## Summary/Reason Statement for DRH16-00014

**Project:** 1401 Idaho

<b>File Number</b>	DRH16-00014
<b>Applicant</b>	FH Broncos, LLC – Eran Fields
<b>Property Address</b>	1808 West Boise Avenue
<b>Public Hearing Date</b>	February 10, 2016
<b>Heard by</b>	Design Review Committee
<b>Design Review Planner</b>	Andrea N. Tuning
<b>Design Review Supervisor</b>	Sarah M. Schafer

**1 SITE PLAN**  
 SCALE: 1" = 20'-0"

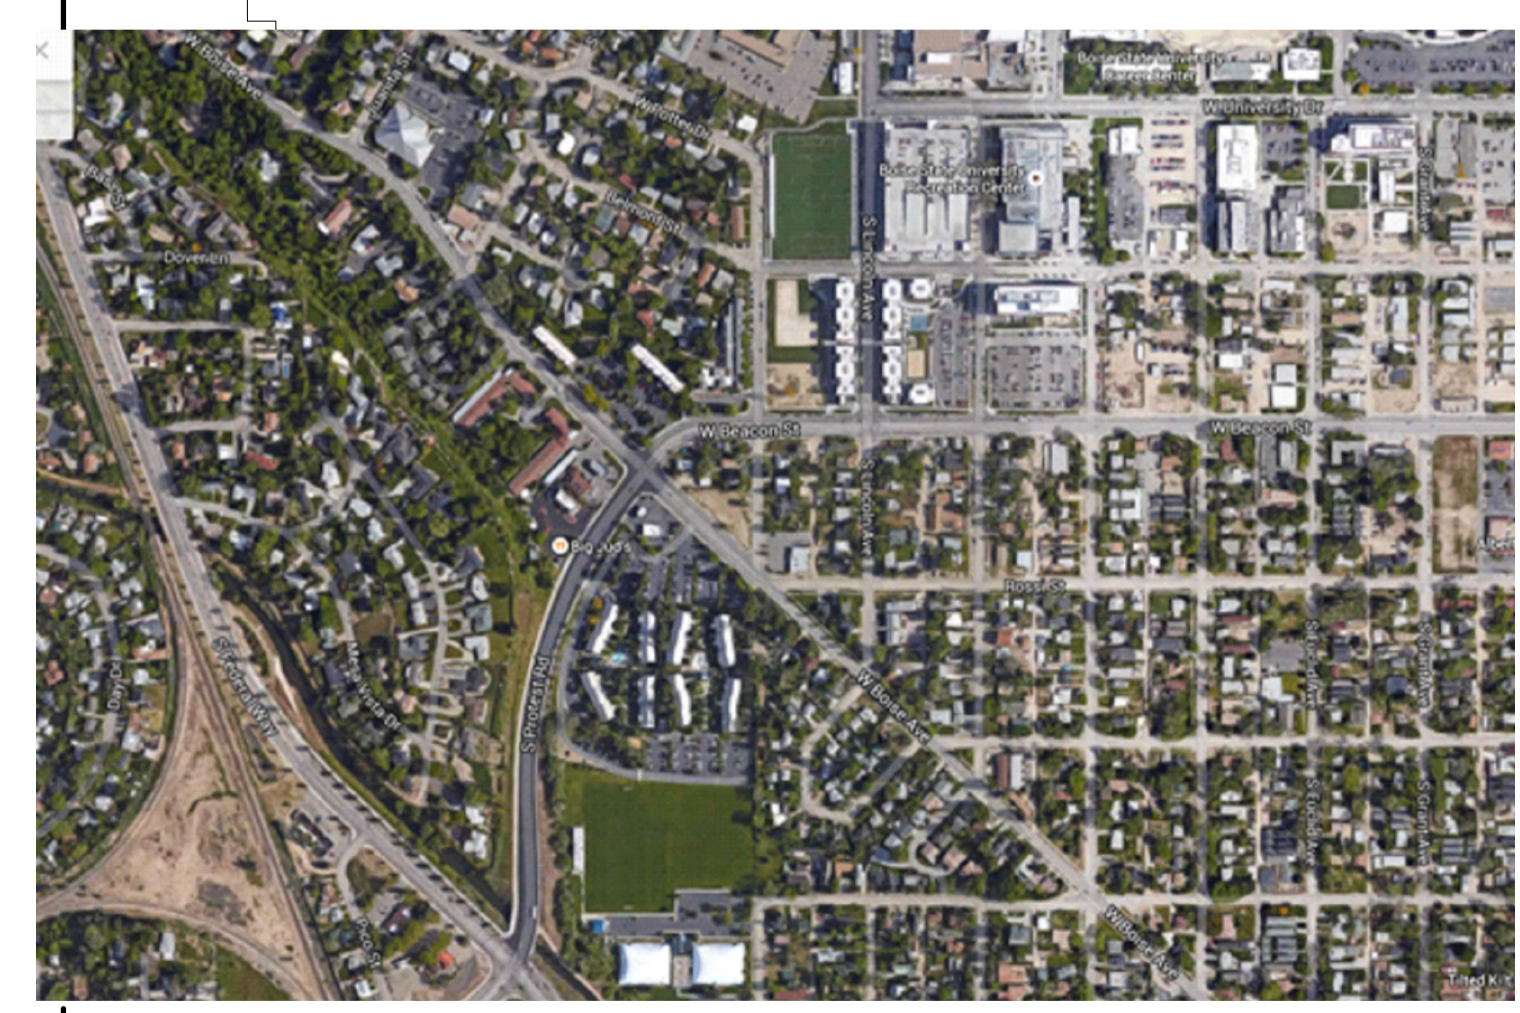
- d. Eliminate the existing driveway on Boise Avenue and replace it with standard vertical curb and gutter to match the adjacent improvements.
  - e. Eliminate the existing driveways on Boise Avenue and replace them with standard vertical curb and gutter to match the adjacent improvements.

**3 NORTH EXTERIOR ELEVATION (W. BEACON AVE.)**  
SCALE: 1/16" = 1'-0"

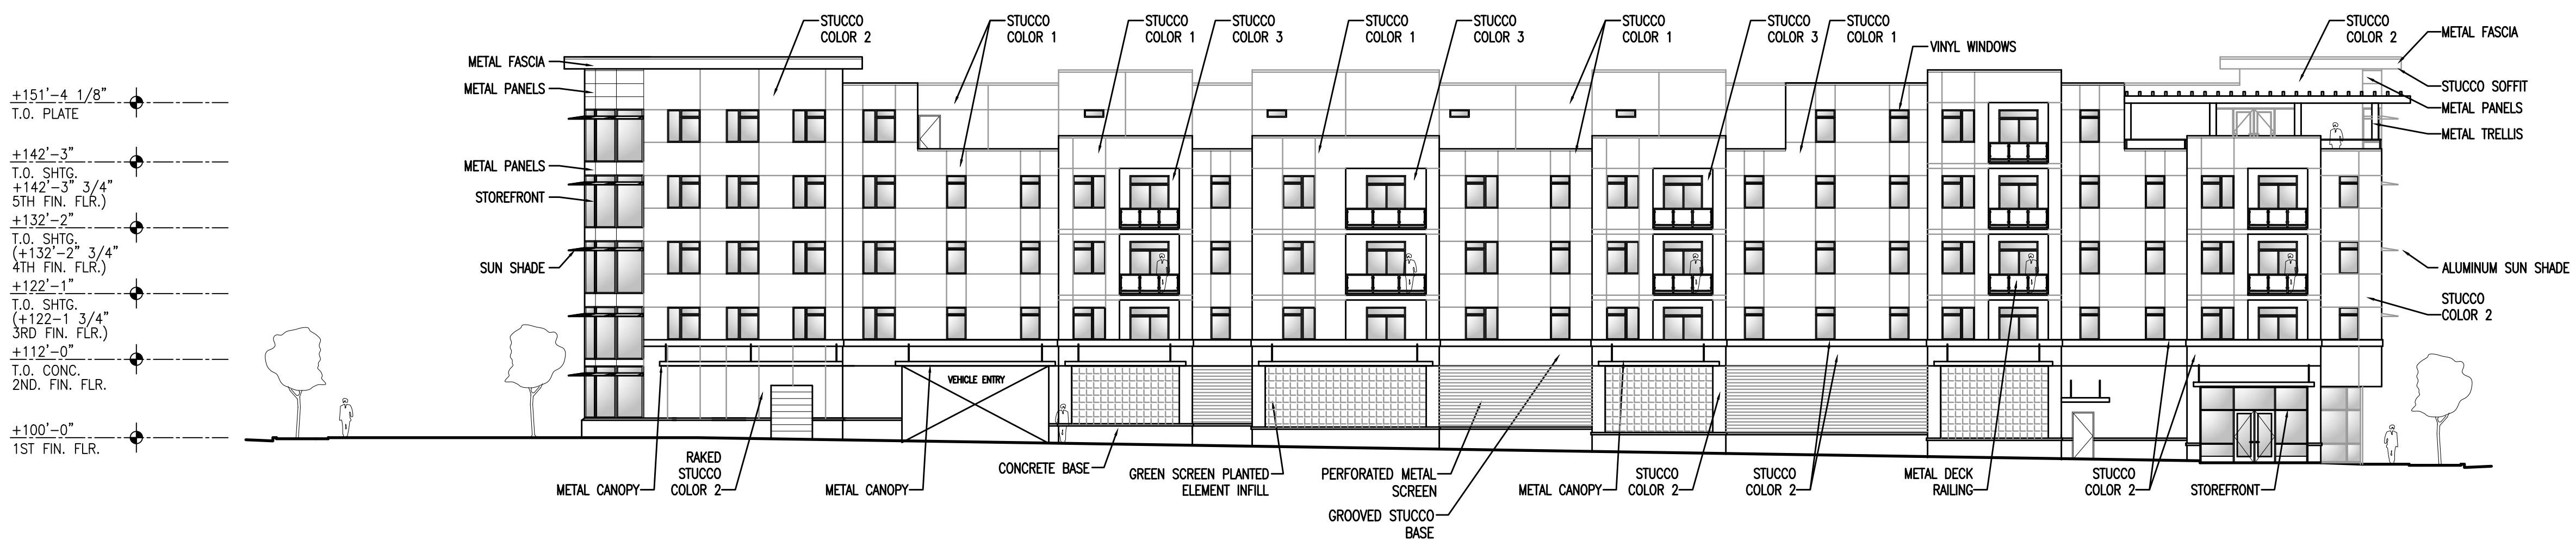
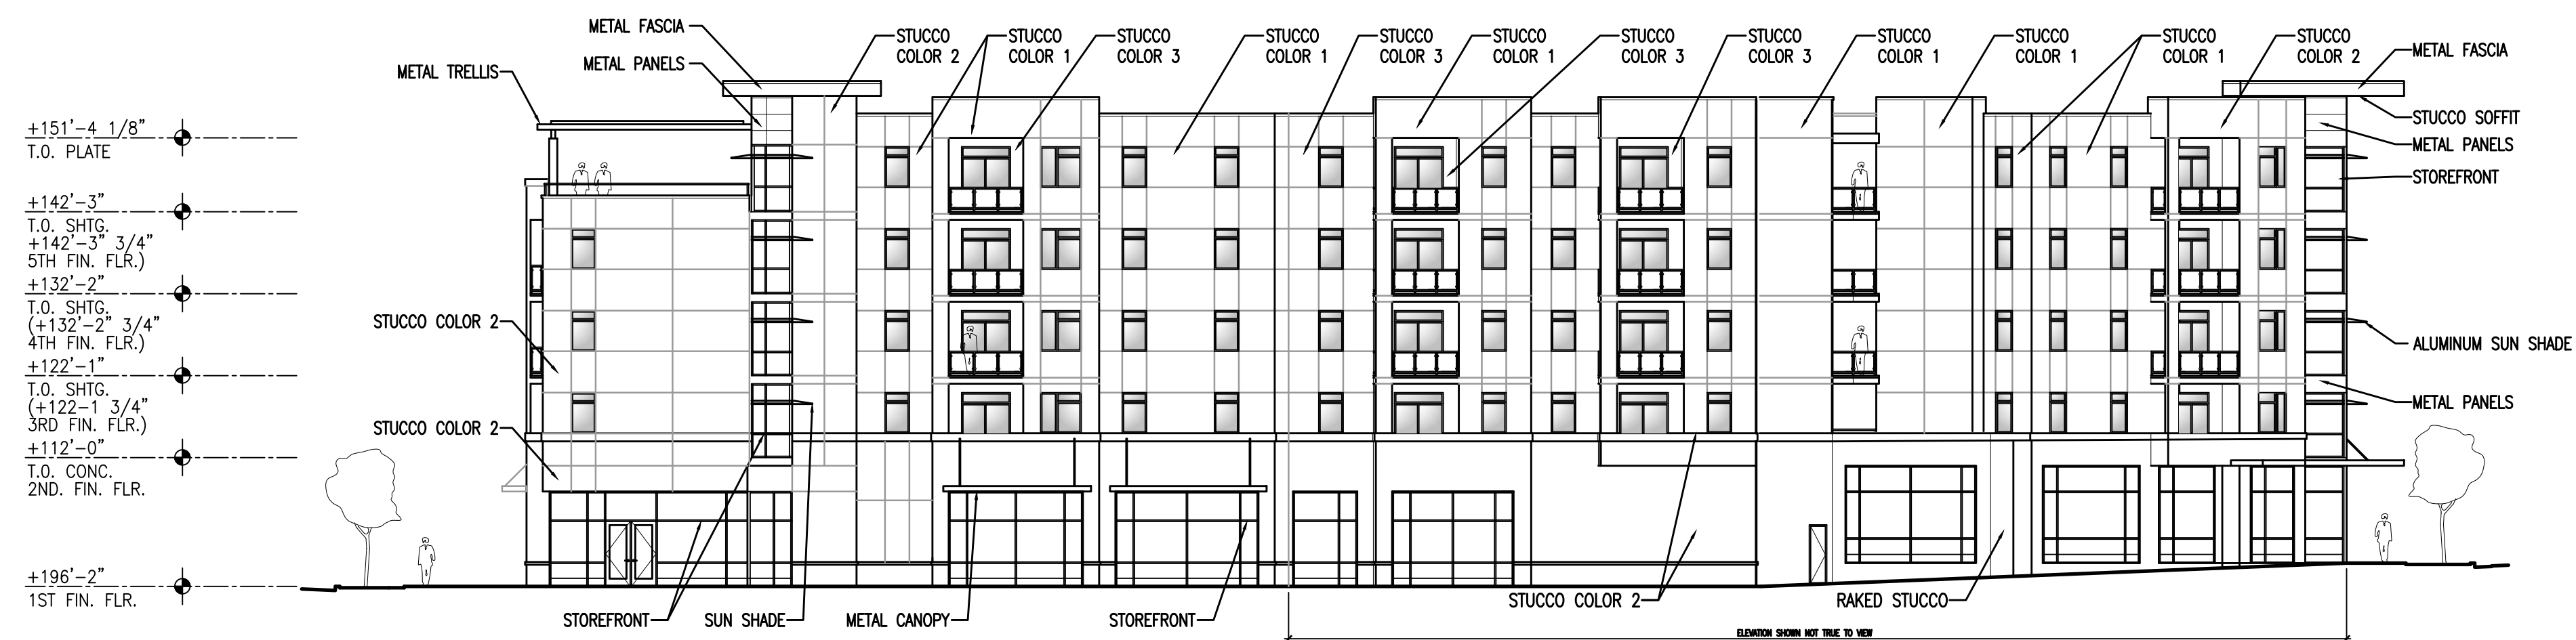
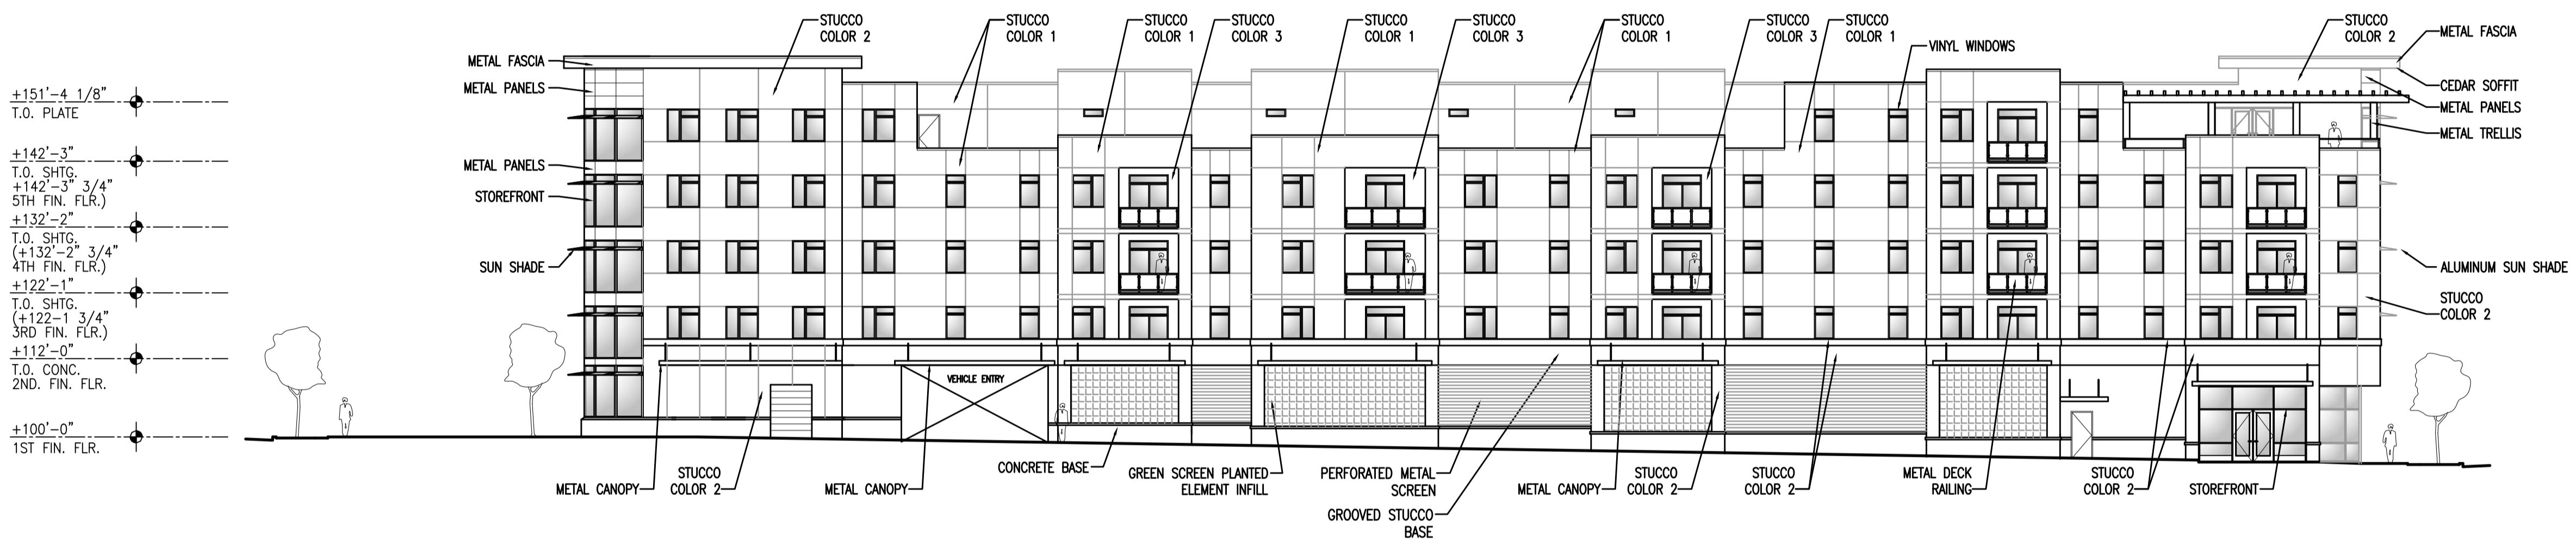
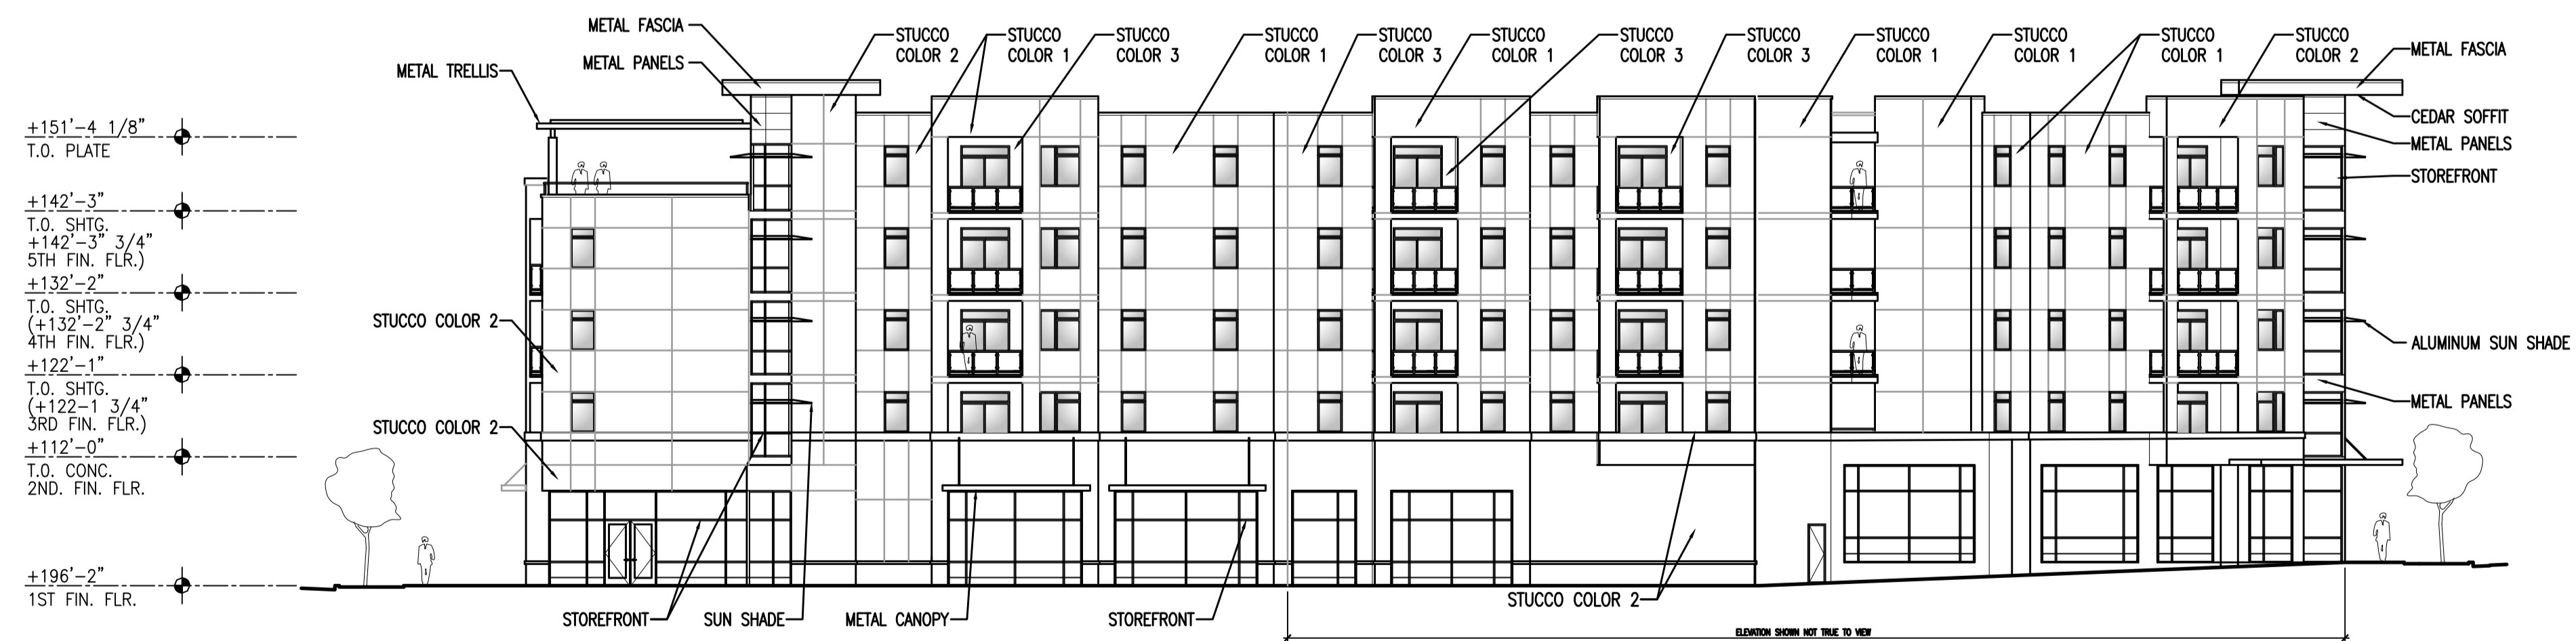
- c. Provide a 3-foot modulation within the wall plane at each location where the building encroaches into the street side setback on Oakland Avenue.
